METRO PLANNING COMMITTEE OF THE TOWN PLANNING BOARD

MPC Paper No. 14/16

**Submission for Compliance with
Approval Condition (b) and Approval Condition (l) of Application No. A/H4/94**

**Proposed Alteration and Modification Works to the Building
and External Façade for Cultural/Leisure/Retail/Food &
Beverage Uses/Open Space/Ancillary Support, for the Central Market
Revitalization Project in “Other Specified Uses” annotated
“Building with Historical and Architectural Interests Preserved for
Commercial, Cultural and/or Community Uses” Zone,
The Former Central Market, 80 Des Voeux Road Central,
Central, Hong Kong**

| Drawings AA-6 to AA-9 | Layout Plans of Market Stall Preservation (G/F to 2/F) |

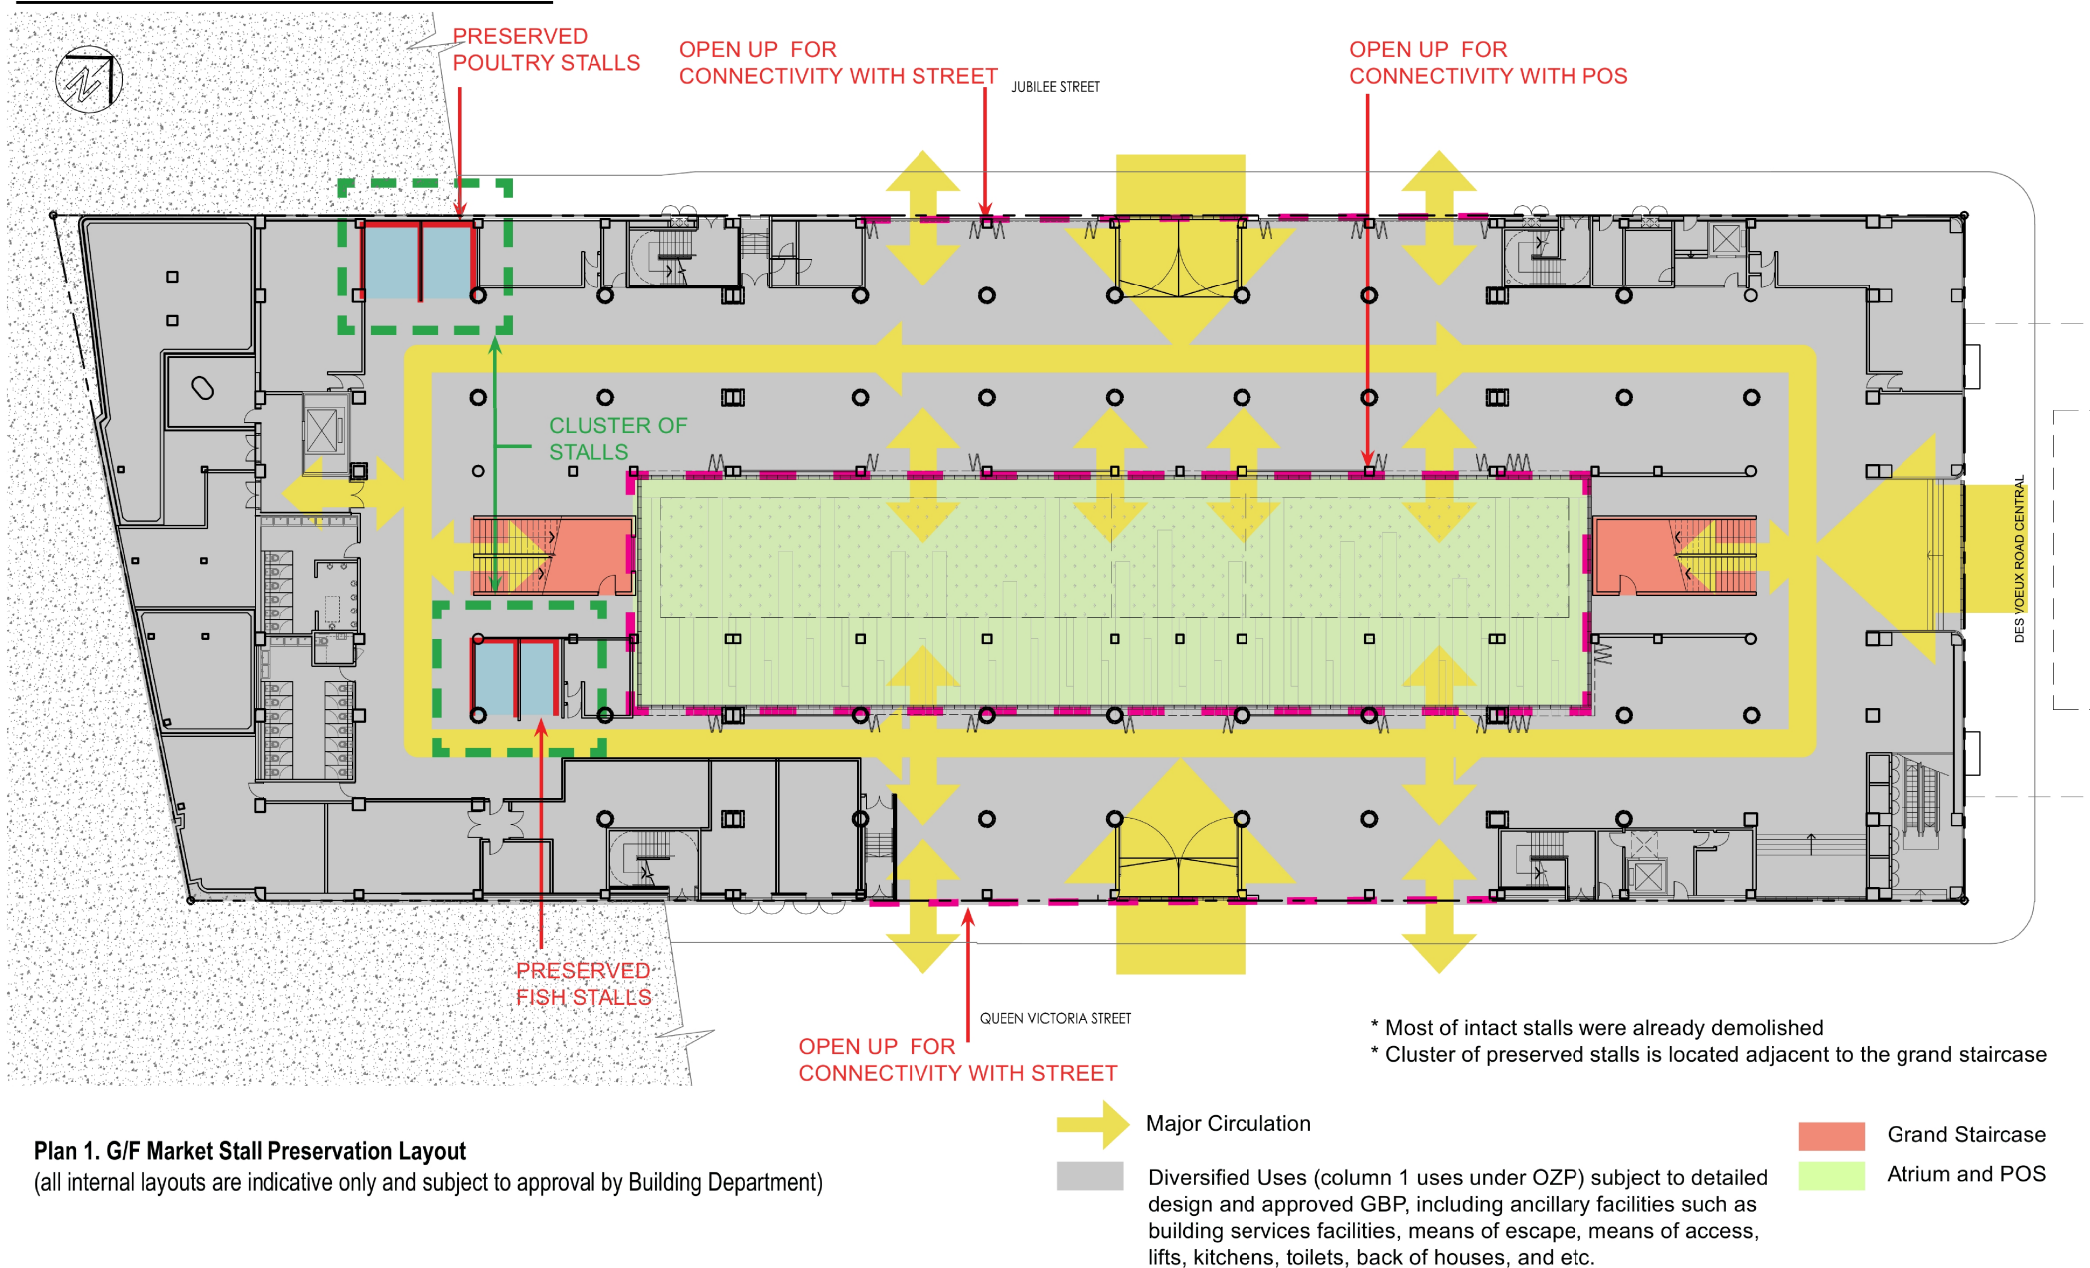
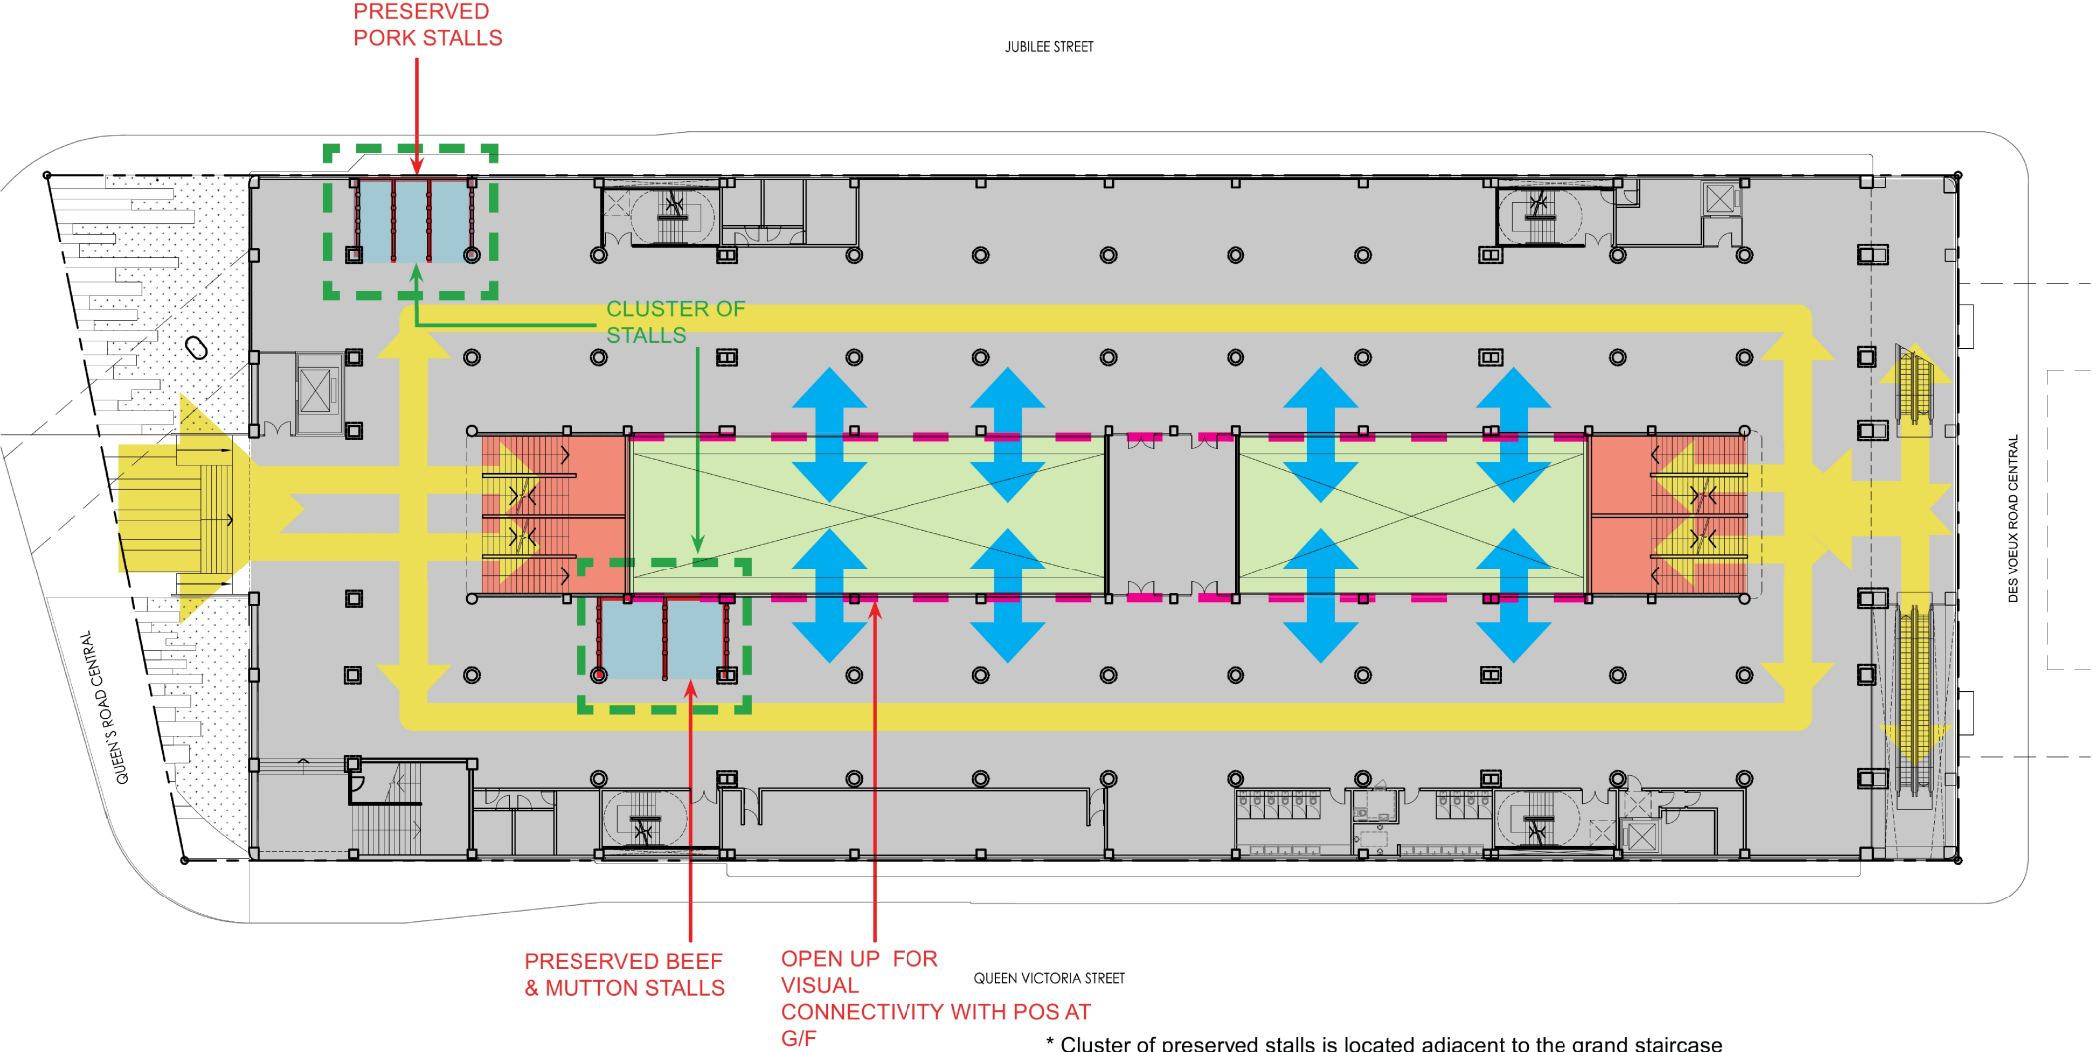
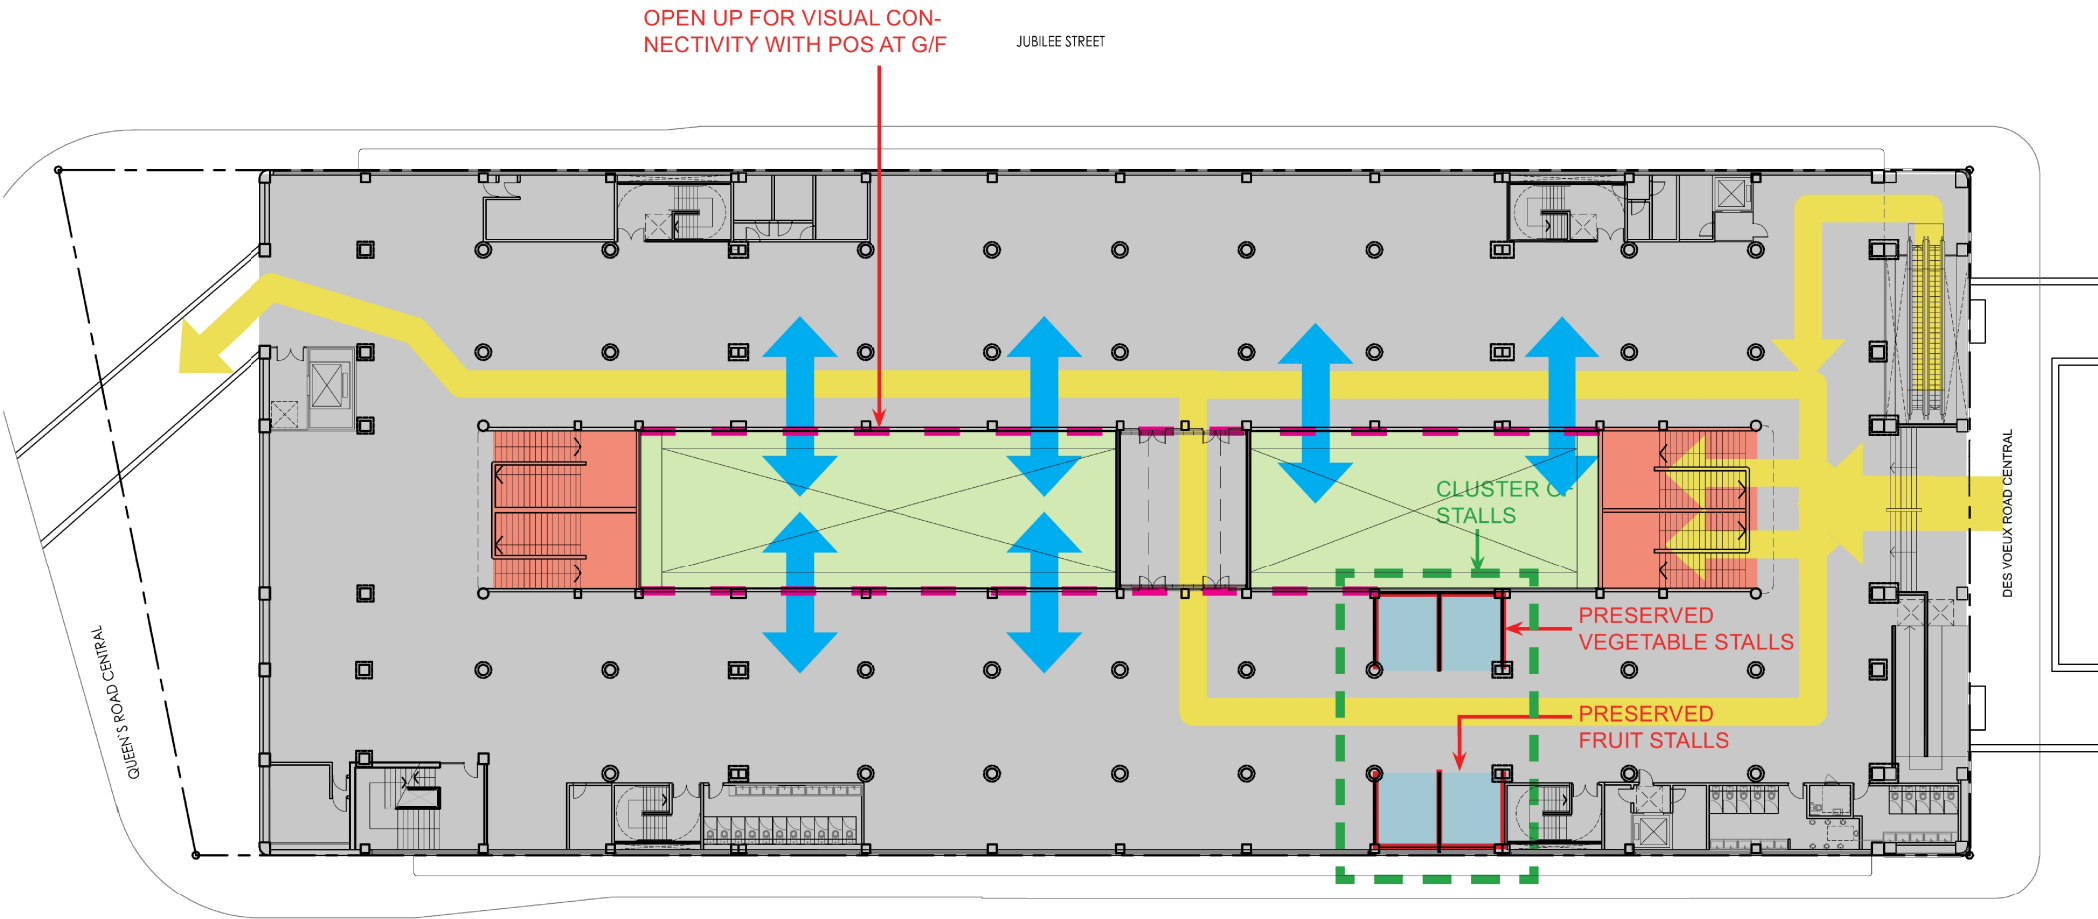
| Department | Comment(s) | URA's Response(s) |
|--|--|---|
| Architectural Services Department (ArchSD) | <p>f) Subject to comment from Antiquities and Monuments Office (AMO) on the current proposal of the preserved stalls, the Applicant should submit detailed design of the shop front and coloured interior perspective of it for comment.</p> <p>g) The proposed uses of different areas are not clearly demonstrated on the layout plans. The Applicant should clarify if open retail plan design is being proposed. For clarity purpose, the proposed zoning like circulation, E/M space, public amenity/toilets, retails, food & beverage, art exhibition and performance area should be indicated on the plans.</p> | <p>We note that AMO has no comment on the market stall preservation plan. ArchSD's comment is duly noted and will be considered in detailed design stage.</p> <p>Approval Condition (l) was imposed by TPB as members considered that a "cluster" of each type of market stall should be preserved. The intention of the market stall preservation plan was to ensure that the quantity and location of the market stalls to be preserved are to the satisfaction of the TPB. The interior design of the building is not required in this submission for the purpose of complying approval condition (l). The market stall preservation plan shall be implemented to the satisfaction of AMO.</p> |

| Antiquities and Monuments Office (AMO) | As regards the Approval condition (l), the applicant is required to submit a market stall preservation plan to the satisfaction of TPB. We have no particular comment on the market stall preservation plan from the heritage conservation point of view. | Noted. |
